Council Reference: A006866747
Attention: Joel Wake

RE: Response to Information Request – Development Permit for Material Change of Use - Multiple Dwelling (27 Townhouses) at 42 Redhead Street, Doolandella

We write on behalf of our client, Sunstate Civil Construction, in response to Council's 1 June 2026 Information Request regarding development at 42 Redhead Street, Doolandella.

Figure 1: Proposed Vegetation Retention Plan – S5 Environmental (14 August 2026)

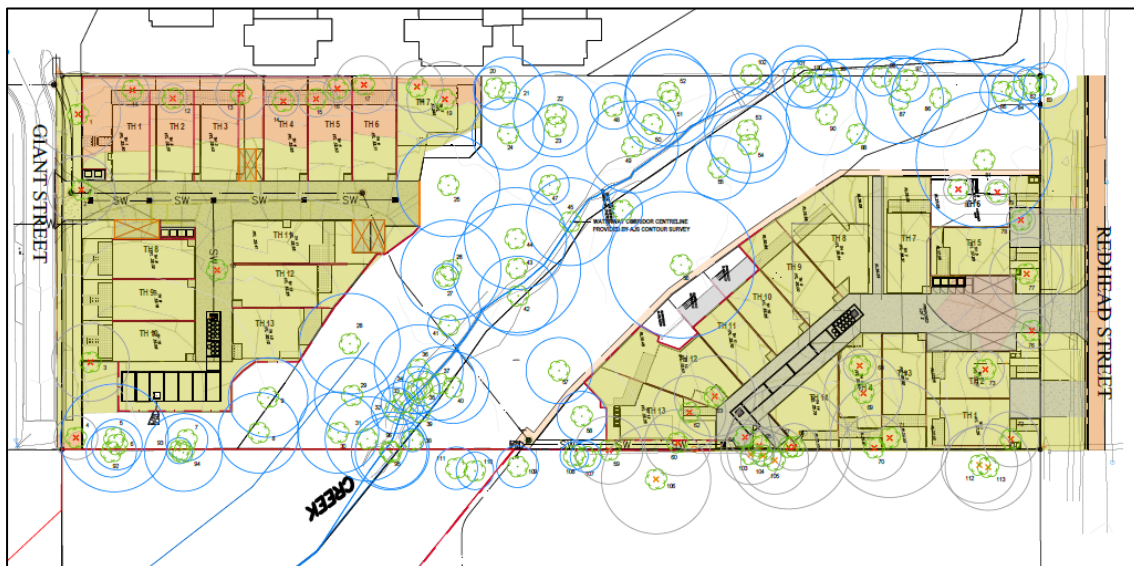
A response to Items 5 & 6 has been provided in the accompanying response to Council information request prepared by S5 Environmental.

However, consideration for the EPZ proposed by Council was undertaken and it was determined the protection zone intended was predominantly guided by the retention of additional trees within the waterway corridor. The current proposal has made consideration for this by providing a widened corridor particularly in the western extent of the property adjoining TH#7 to approximately 30m from the identified centre line. This amendment to the proposed corridor has allowed for the retention of T21, T22, T24 and T25. Further to this several design changes have been made which allow for the retention of T81, T56 and T9 within areas of common property.

A revised Arborist Report prepared Independent Arboricultural Services also accompanies this response, suitably addressing Item 6. All trees identified by Council in item 6 are now to be located within the common property of Stage 1 or the dedicated waterway corridor, enabling their ongoing retention. All other relevant items have been suitably addressed. The proposed corridor width continues to tie in neatly with the widths of the approved development to the West (A004072658) and the proposed development to the East (A006711283) and their respective corridors.

The revised waterway corridor and additional tree retention represents a balanced outcome, securing a meaningful ecological corridor, protecting select trees beyond the main corridor and accommodating dwellings at an appropriate density in a well serviced location.

Figure 2: Section D from Preliminary Civil Concepts – DRW Consulting (07 August 2026)

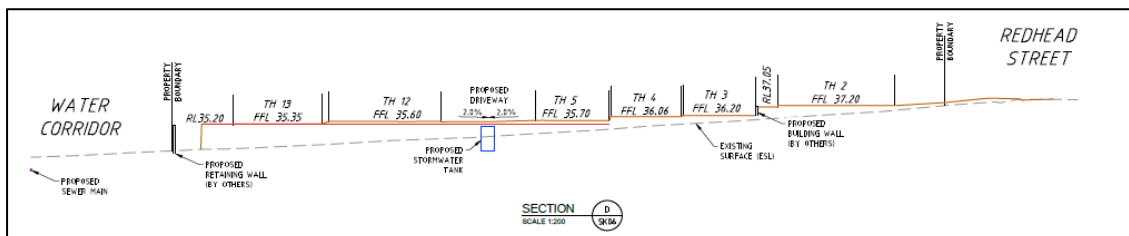
- 7) The stormwater strategy is supported with detention and water quality however; the below outstanding issues need to be addressed:
- Provide a swale along the eastern boundary of TH13 to manage major/blockage flows and ensure the TH13 floor level is at least 200mm above the top of that swale;
 - Ensure TH13 is at least 150mm higher than the road where detention tank is proposed to ensure major flows or blockages will spill along the eastern boundary. Its FFL should be slightly higher at 35.4m AHD; and
 - Detention tank requires a sag in driveway to capture major flows. Ensure lot levels are at least 150mm above the tank inlet pits.

- A swale along the eastern boundary adjoining TH13 will provide flows from the northern pad through to the waterway corridor. As demonstrated by Section D on drawing 25303-P1-C, TH#13's finished floor level is to be 35.53m AHD.
- The FFL of TH#13 is above the inlet level of the proposed detention tank.

- A 2% fall from the edge of the crossover towards the centre is proposed.

Figure 5: Site Context Plan with Proposed Building Separations – Ian Webb Architect

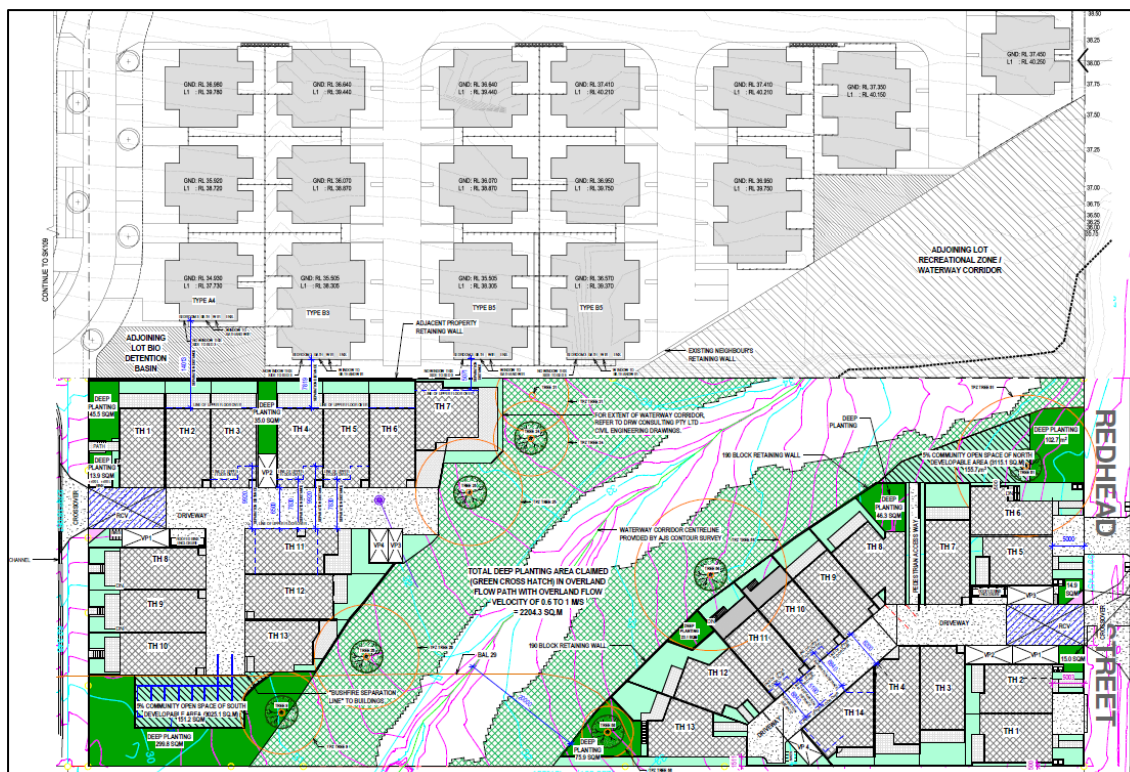
- 24) – Building Separation
- 25) – Site Cover

As detailed on the revised Architectural Plans, a minimum internal separation of 6500mm (ground floor) and 7830mm (first floor) between TH#11 and TH#4 is proposed. Elevation 2 of Drawing DA203 shows that TH#11 and TH#8 both include only a single first floor window where there is to be no direct view lines between the units. It is requested that Council impose standard screening conditions where reasonable to mitigate impact.
